Dealer Service Instructions for:

Safety Recall W24 / NHTSA 20V-207 Bed Step

2019-2020 (DJ) Ram 2500 Pickup

Figure 1 – Old Bed Step Brace

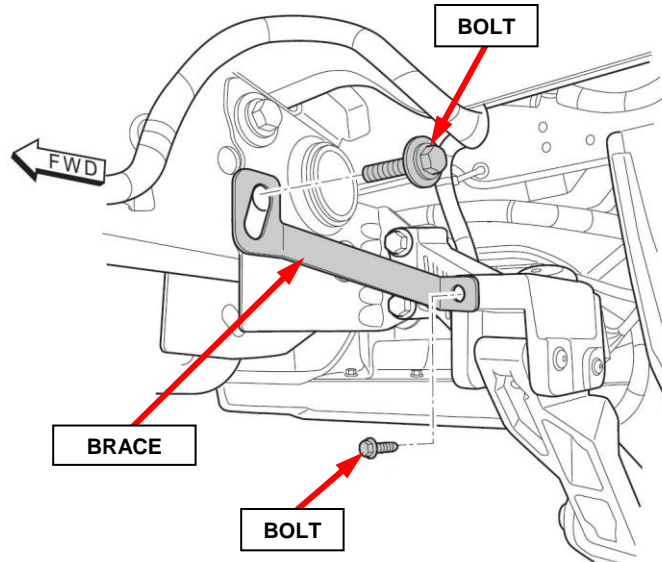
2. Remove the two bolts securing the bed step brace and **SAVE** the large M16 bolt, **DISCARD** the small M8 bolt (Figure 1).

3. Remove the recalled bed step then render it unusable and **DISCARD**. (Figure 1).

Figure 3 – New Bed Step Brace

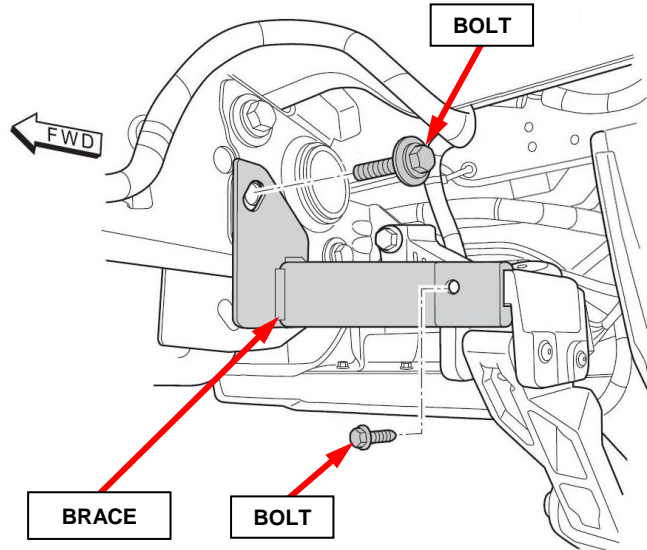
5. Install the **NEW** bed step brace (Figure 3).

6. Loosely install the **NEW** M8 bolt included in the campaign kit then the M16 bolt saved from the removal step (Figure 3).

NOTE: Do NOT tighten the bolts.

Figure 4 – Bolt Tightening Sequence

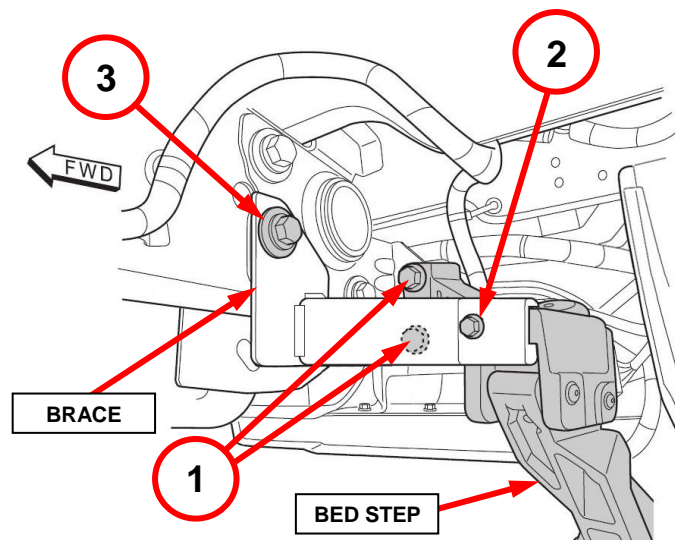
7. Tighten the bolts in the following sequence (Figure 4):

NOTE: After tightening the bed step bolts (1) and before tightening the bracket bolts (2, 3) check for clearance between bed step and bumper with bed step in the stowed position. Adjust as necessary to avoid any contact.

- (1) M10 bed step bolts.
68 N·m (50 ft. lbs.)
- (2) M8 brace bolt.
22.5 N·m (16.5 ft. lbs.)
- (3) M16 brace bolt.
140 N·m (103 ft. lbs.)
